Architectural Design Report - Response to Submission

# UNSW Health Translation Hub

This report has been prepared on behalf of UNSW as an addendum to SSD 10822510 for the Health Translation Hub building.

The report has been compiled to respond to the design-related submissions received by the Department of Planning and Environment and Randwick City Council during the public exhibition of the UNSW HTH.

## Item 24. Public Drop Off

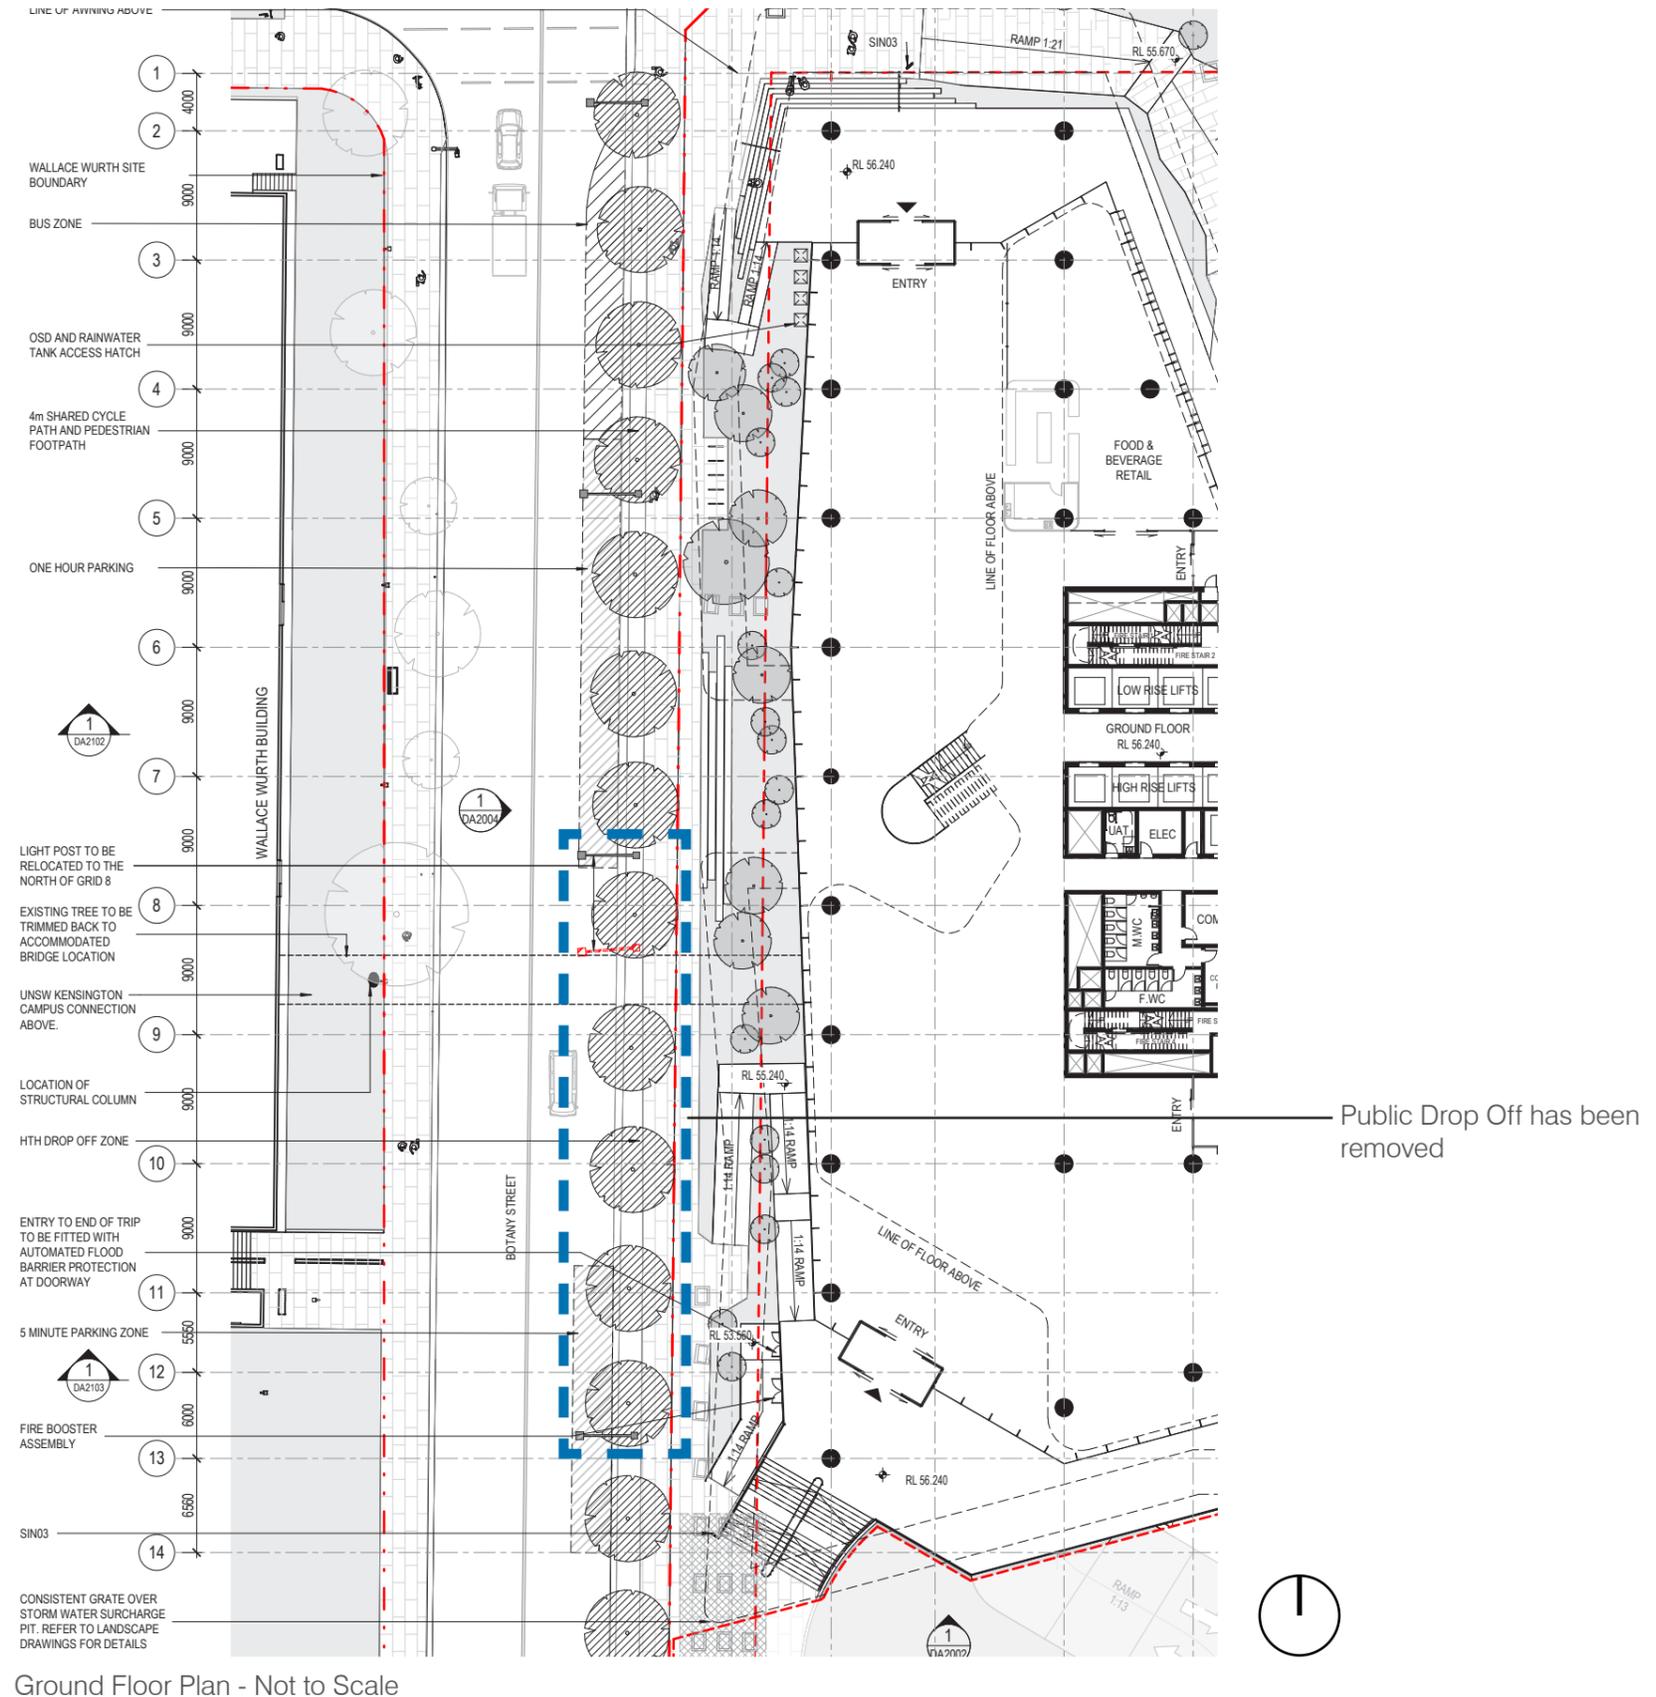
Remove indented drop-off spaces on Botany Road and provide updated plans to reflect the removal.

The creation of an intended parking bay for the 'Pick Up/Drop Off' (PUDO) task along Botany Street is not supported. Along a 55m length of 1 hour parking, the creation of a PUDO bay affords no benefit. Indeed, the creation of the proposed PUDO actually reduces parking efficiency due to the required angled transition from the existing kerb line to the recessed kerb line. Council recommends simply signposting the PUDO area while maintaining the existing shared path and providing the opportunity to continue some low level Botany Street landscaping elements. This signposted area will accommodate the PUDO task and have the adjacent shared path maintained at full width. In addition, a 'signposting only' solution provides flexibility to increase (or decrease) the length of the PUDO zone in the future, depending on demand over time.

The design team supports the recommendation to remove the public drop off zone. The street, kerb and shared footpath has been reinstated in the revised plans in Attachment A, and further information is provided in the Transport and Traffic Report.

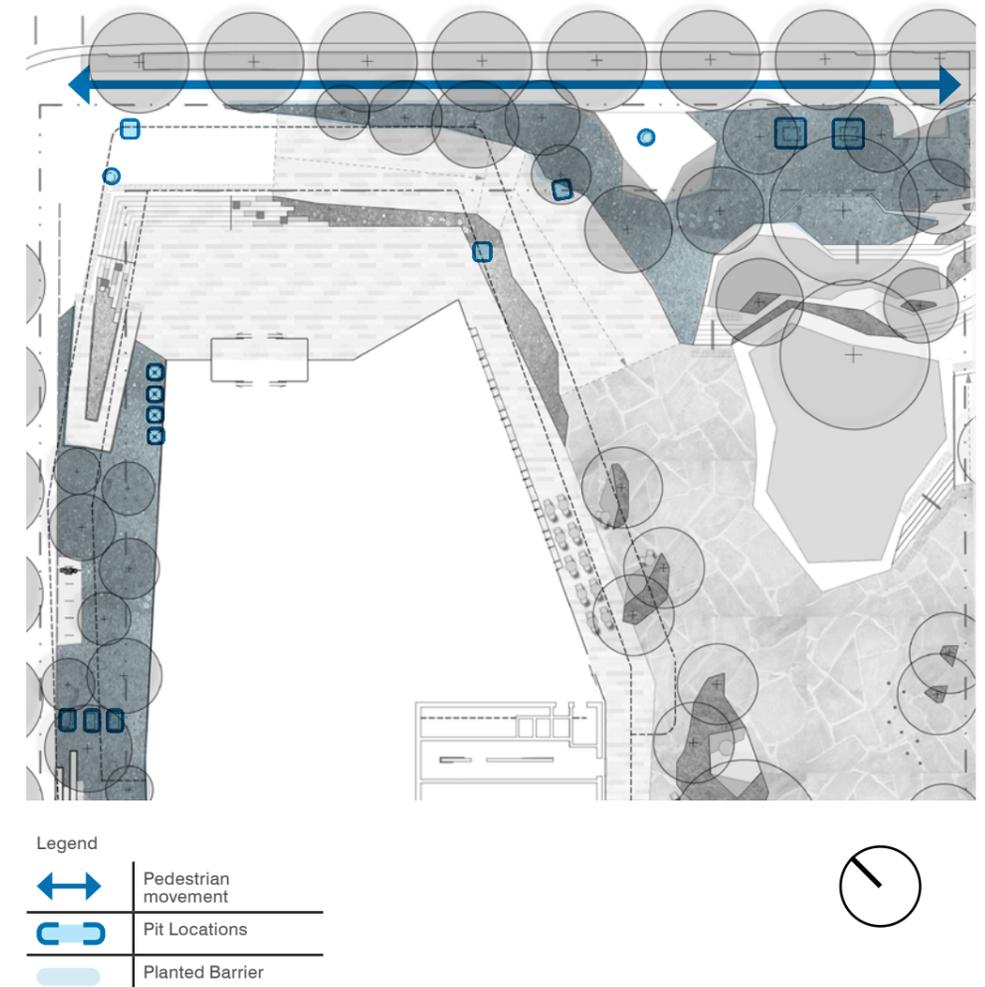
The proposed pedestrian footpath along High Street is approximately 2.5m wide with a nature strip of approximately 1m to 1.2m. Council requires a minimum footpath width of 4m to 5m to provide for the increased density of new development and to cater for projected increased pedestrian and bike rider movements along High Street, including movements generated by the Light Rail station. It is understood that flooding constraints have informed the design of the footpath and landscaping along High Street, however widening of the footpath width in this location should be further investigated.

sympathetic landscape treatment. A wider footpath would increase the slope of the landscape embankment and would raise the height of the retaining wall adjacent to the High Street footpath.

- Increased gradient of the proposed 1:26 footpath, which would impact the seamless accessible transition between the existing footpath and UNSW Plaza.
- Introduction of a 650mm retaining wall to High Street, which would impact public amenity, connectivity and views into the UNSW Plaza. The avoidance of retaining walls as much as practical is an important project principle facilitating a pedestrian pathway that reduces boundary lines and promotes an inviting and equitable key entry.
- A reduction in potential for tree planting in the landscape zone.
- Increased potential for landscape erosion and plant failure on the embankment.

Shadow Analysis

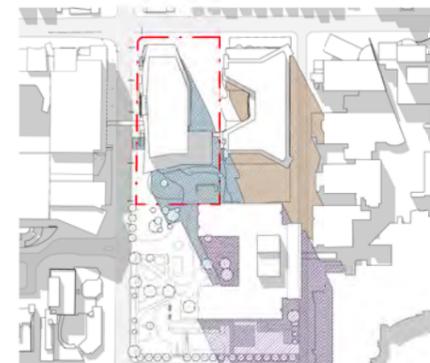
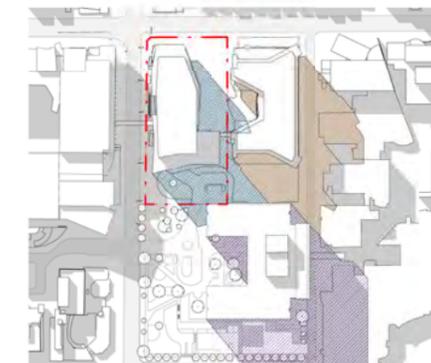
The shadow diagrams provided are limited, addressing only the early morning, midday and late afternoon. Hourly shadow diagrams at the June 21 should be provided to assess solar access and amenity.

Please find the additional shadow diagrams adjacent, and also included in Attachment A.

### Item 33. Landscaping

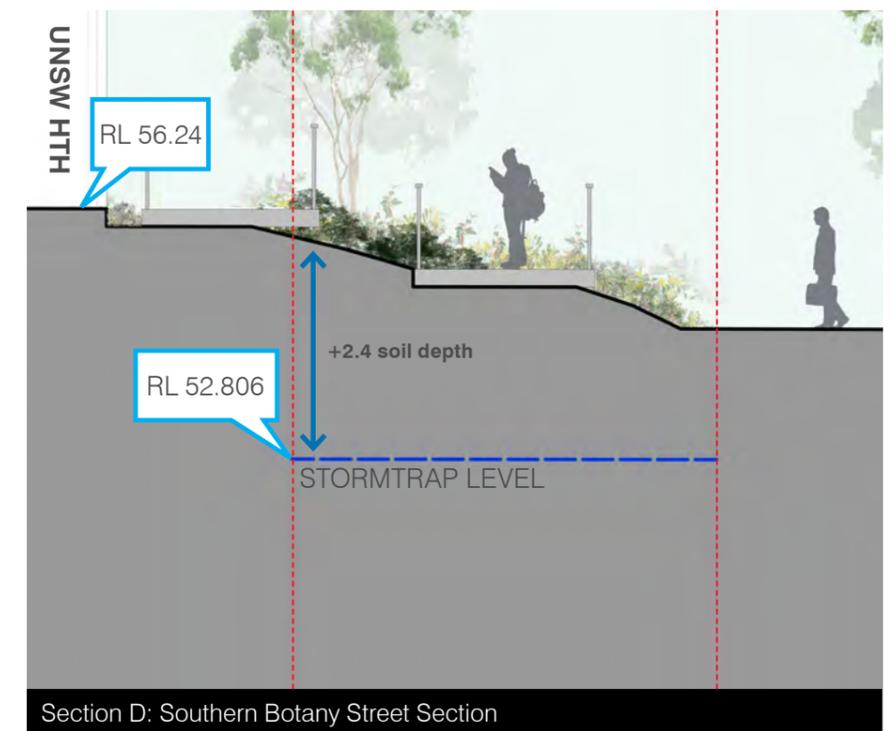
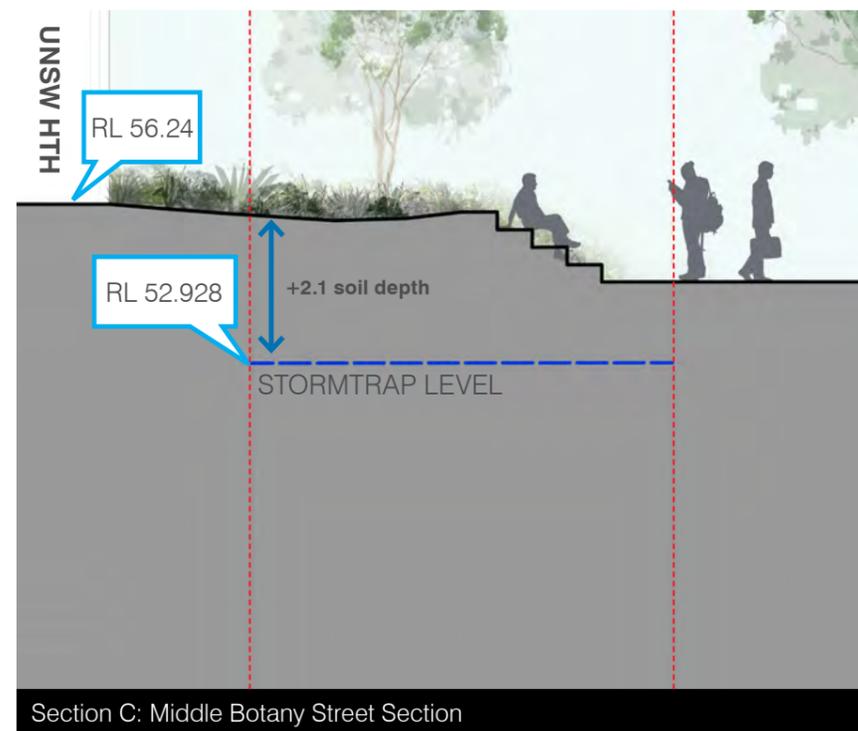
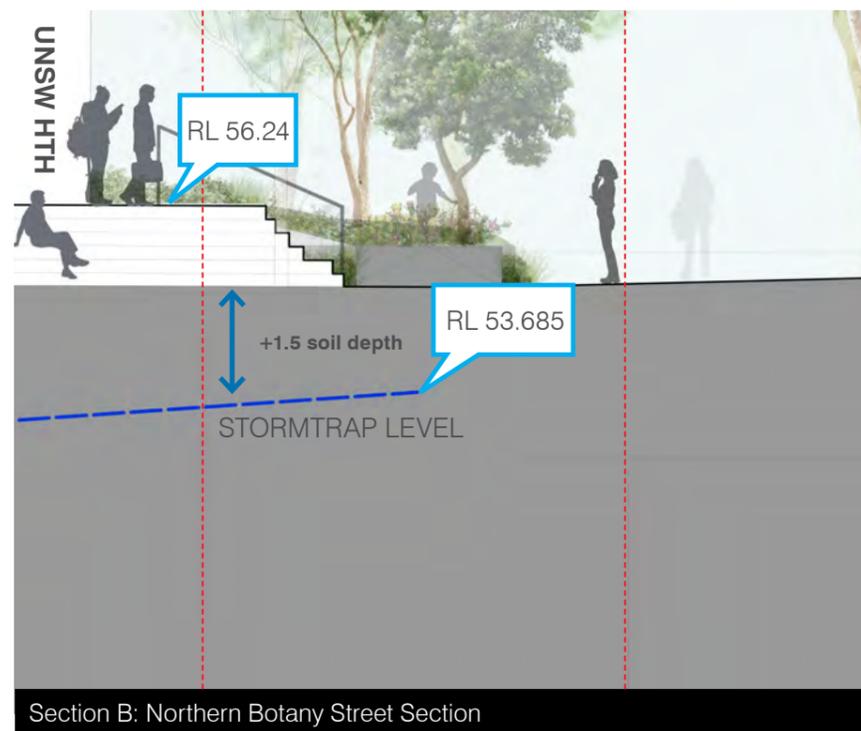
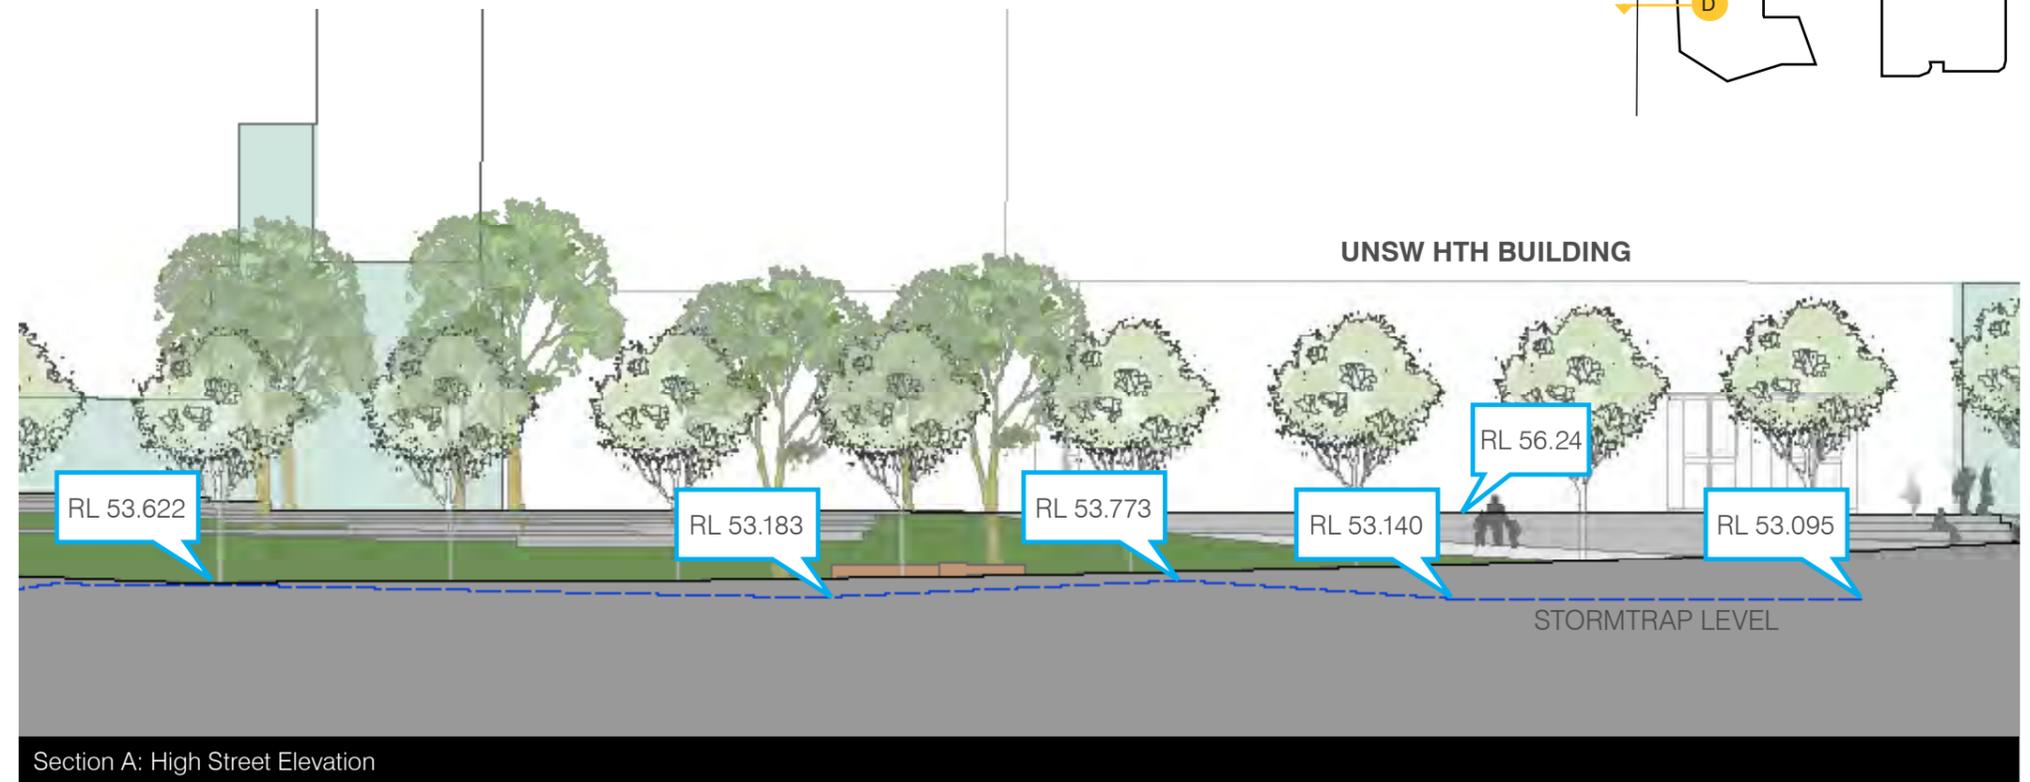
A 6m wide stormwater culvert easement of 6m applies along the UNSW HTH, High Street and Botany Street site boundaries. Concern is raised regarding the ability to plant trees above this service. Proposed landscaping should be reviewed to ensure adequate soil mass and depth is provided over the culvert structure.

The design team has investigated the soil mass and depth allowed for as result of the stormwater culvert. This varies in depth across Botany and High Streets as evident in the sections adjacent. To maximise mass planting and tree canopy coverage, we proposed landscaped embankments which allow for an increased soil depth. Planting and tree coverage are minimised in areas where the soil depth is inadequate.
